Decision on Transpower's Bunnythorpe-Haywards Lines A and B major capex proposal

NZCC 11 [2014]

Date of decision: 09 May 2014

Figure C1 Transpower's demand forecast

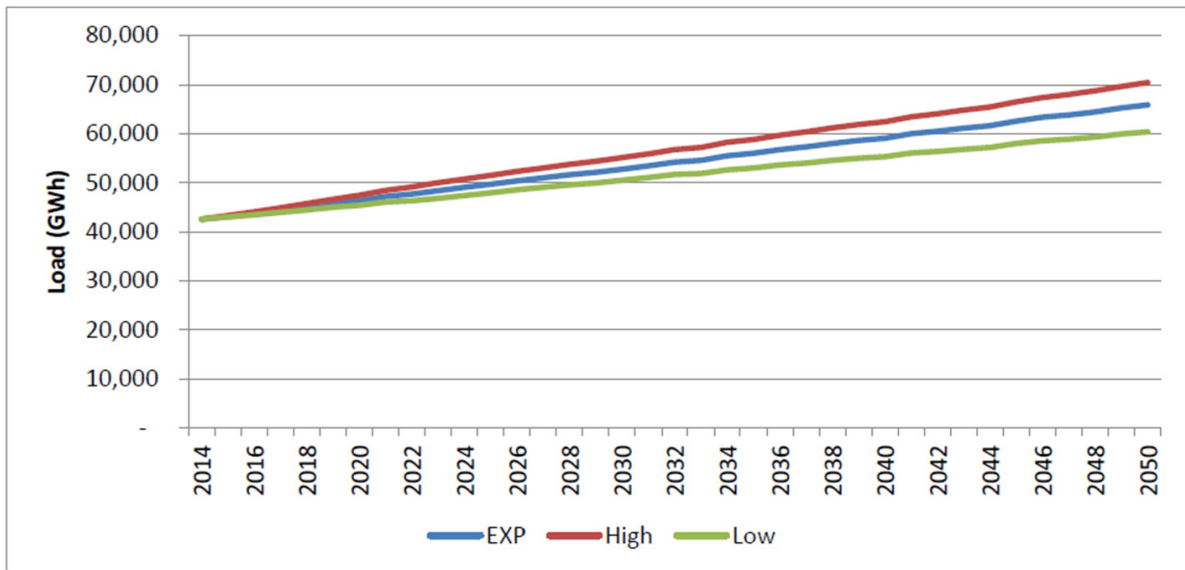
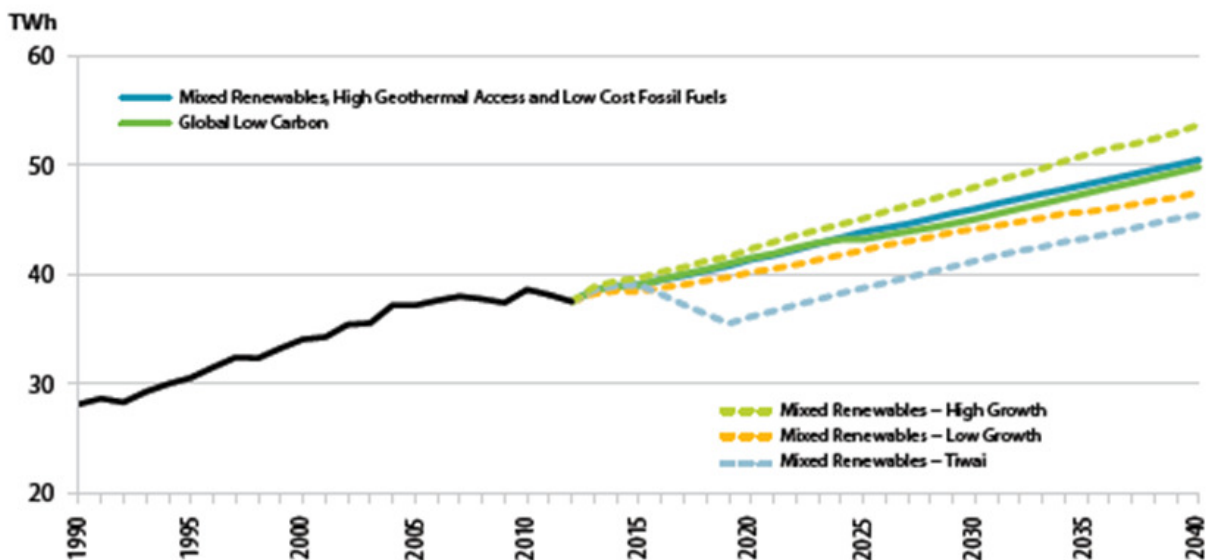
C34 We observe that MBIE's high growth forecast is similar to Transpower's low demand forecast. Transpower's expected and high demand forecasts are higher than the high growth forecasts of MBIE. By 2040, Transpower's forecast demand would be more than 60 TWh while MBIE's high growth forecast is closer to 50 TWh.

C35 We are also mindful that it is impossible to forecast electricity demand accurately. Instead of judging which of the two forecasts are more reasonable, we considered the impact of the two forecasts on the investment tests.

Figure C3 Demand forecast - MBIE's and Transpower's less loss and embedded demand

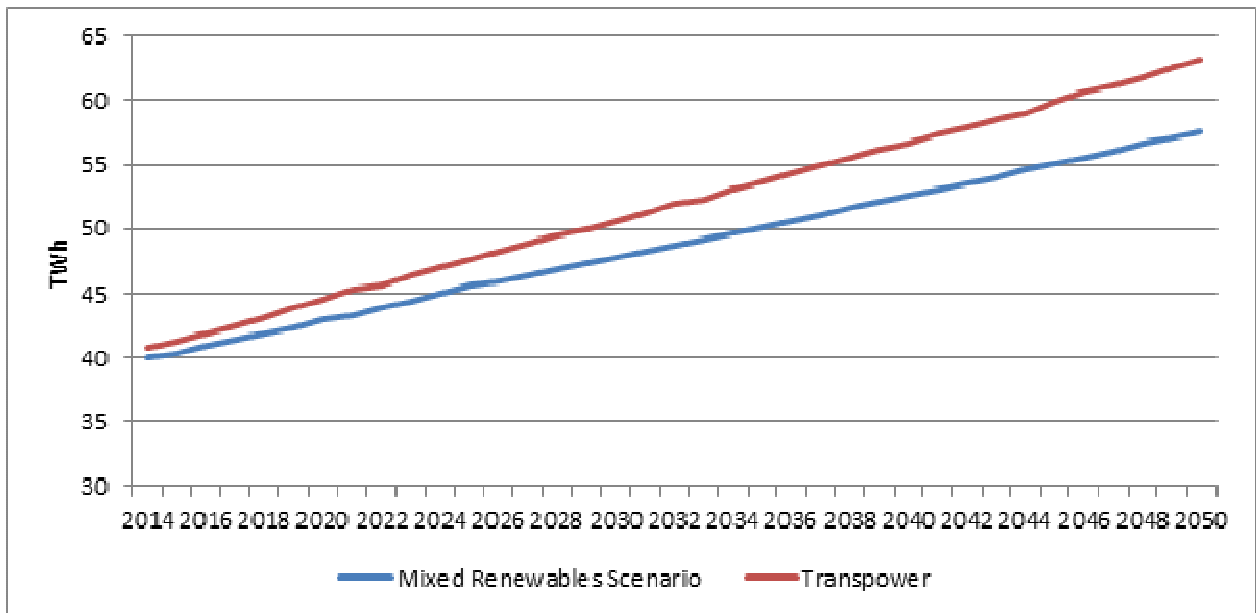
- C39 While in this case, we consider that the demand forecast Transpower used is high, we are satisfied that it has acted within the requirements of the Capex IM. Our analysis highlights the need for MBIE to release the EDGS as soon as practical.
- C40 As discussed earlier in this paper; we expect Transpower to act in accordance with good electrical industry practice, actively monitor demand and update its project plan appropriately. Costs should not be incurred without sufficient justification, challenge and assurance.
